**Committee of Experts on the Transport of Dangerous Goods  
and on the Globally Harmonized System of Classification  
and Labelling of Chemicals****Sub-Committee of Experts on the Transport  
of Dangerous Goods****Sixty-first session**

**Work on the Globally Harmonized System of  
Classification and Labelling of Chemicals: other  
matters****Amendments to the classification of desensitized explosives  
according to the GHS****Transmitted by the experts from Germany and the United States of  
America\*****Background**

### Proposed amendments to Chapter 2.17 of the GHS and Section 51 of the Manual of Tests and Criteria

*Decision logic 2.17.1 for desensitized explosives*

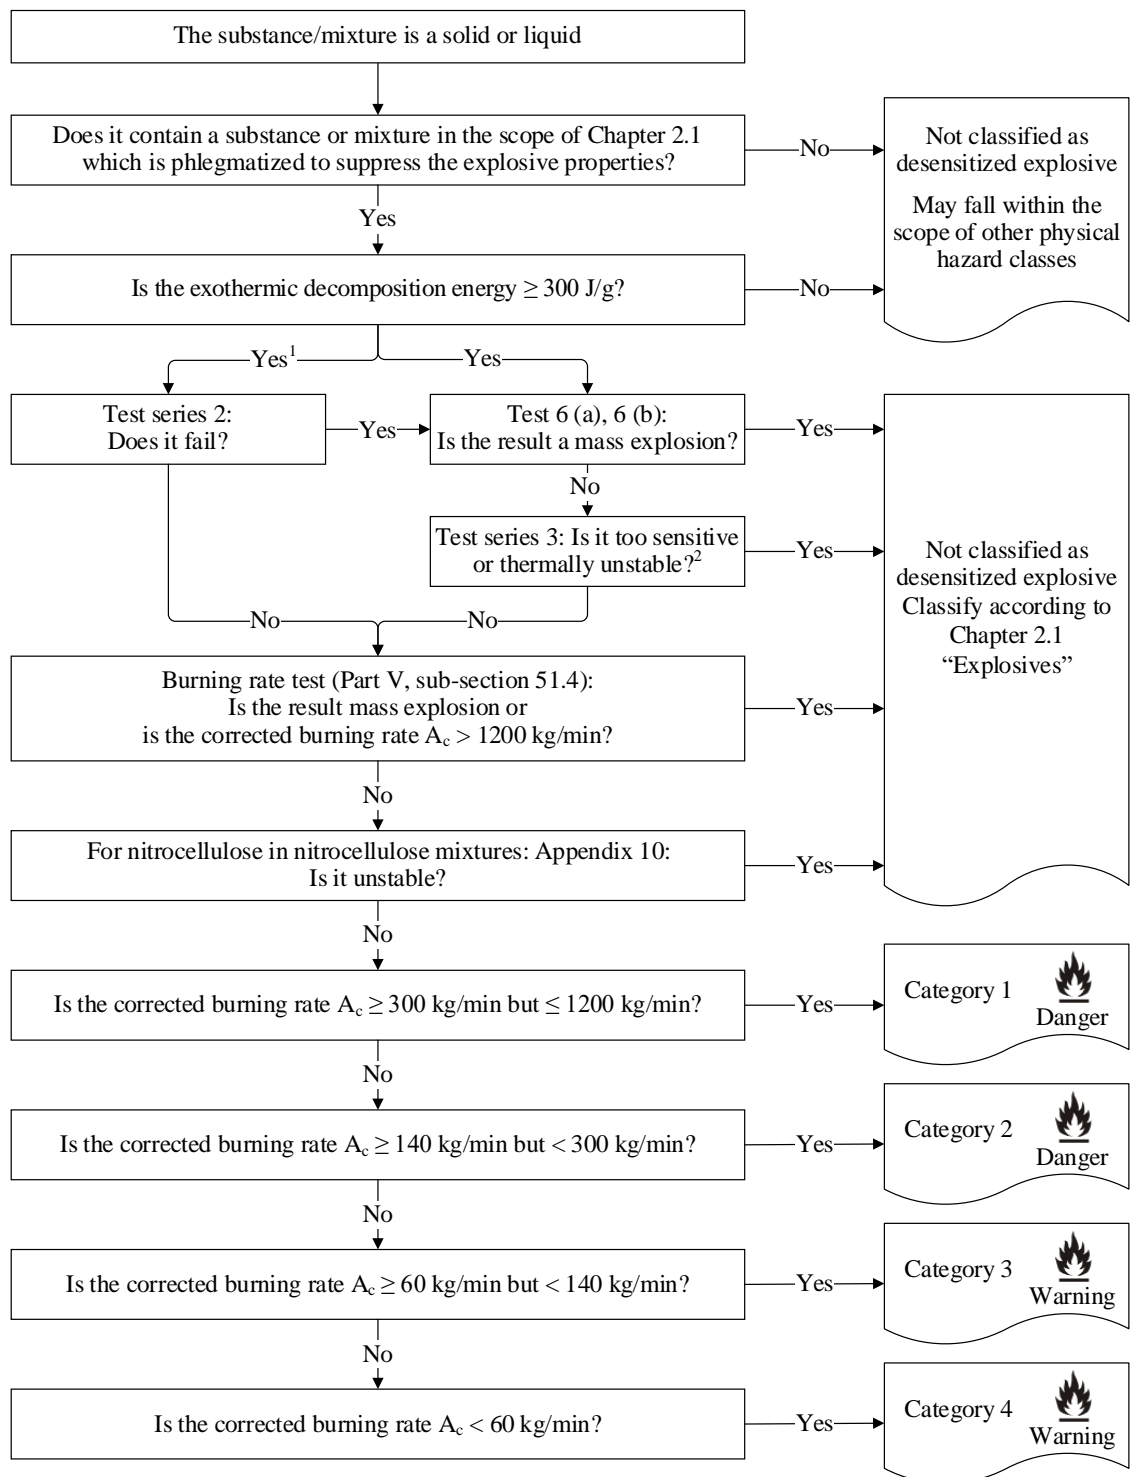
Decision logic 2.17.1 Replace with the following:

Insert the following footnotes:

<sup>1</sup> Test series 2 is optional. The alternative route (via test 6 (a) and (b) and test series 3) may be taken directly without performing test series 2.

<sup>2</sup> Test series 3 is not applicable to nitrocellulose mixtures containing no other explosives than nitrocellulose.
